Product Change Notice (PCN)

PCN Number: **PCN-0450073R-01**

Product(s) Affected: *MJ-3536*

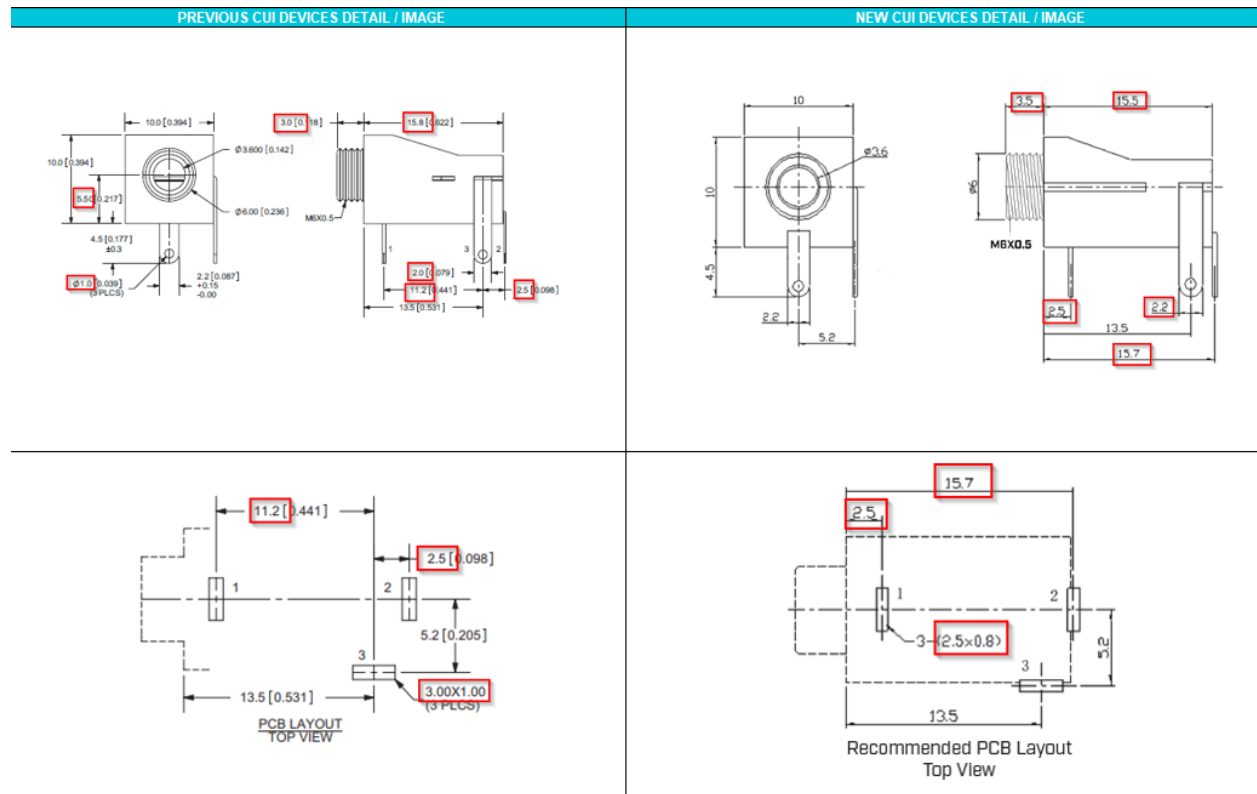
Description of Change: *Minor Housing and footprint differences. Material Change on the housing and terminals. See image Below*

PREVIOUS CUI DEVICES DETAIL / IMAGE			NEW CUI DEVICES DETAIL / IMAGE		
	MATERIAL	PLATING	DESCRIPTION	MATERIAL	PLATING/COLOR
terminal 1	brass	tin	terminal 1	brass	silver
terminal 2	copper alloy	tin	terminal 2	brass	silver
terminal 3	brass	tin	terminal 3	brass	silver
bushing	brass	nickel	bushing	brass	tin
plastic	PBT		housing	PA (UL94V-0)	black
